Product Change Notification

1. ECN #: 270375

- PET - PET Power Terminal

- PET-XX-XX-X-VT-XX-FOOTPRINT

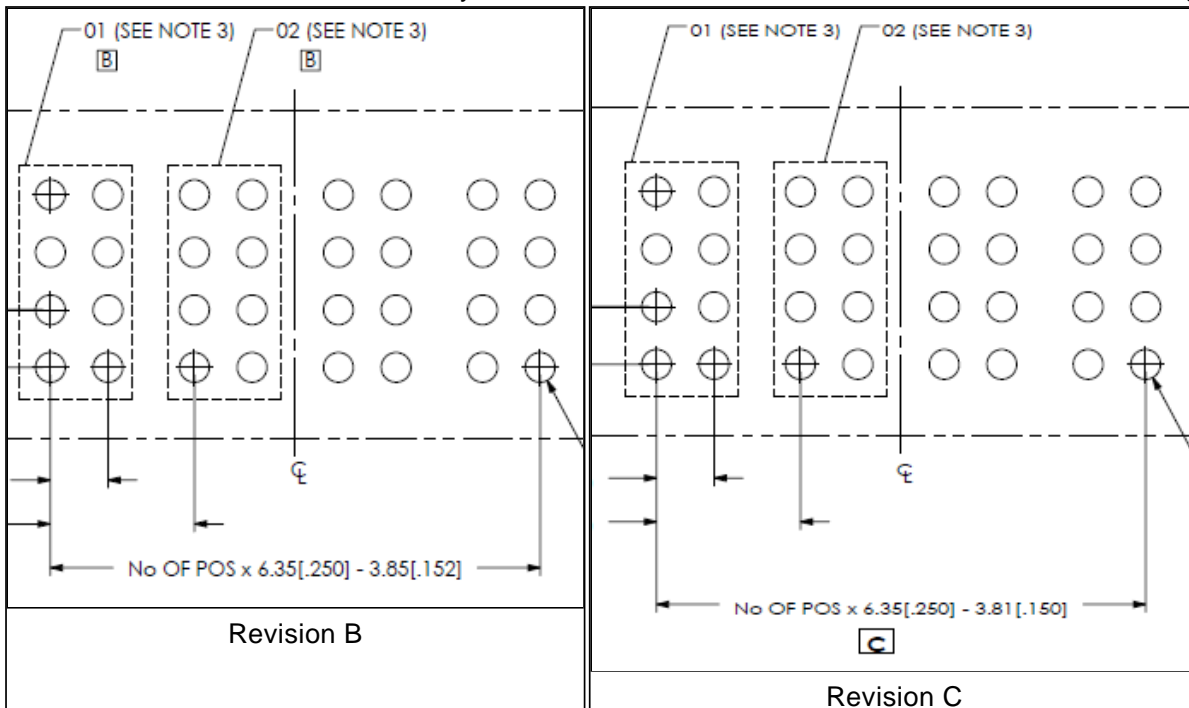
This is an adjustment to the first to last pin calculation to improve the fit of the part to the board.

There is no visual difference. The only difference will be the measurement from first to last through hole.

- Fit - Changing dimension of first to last pin location
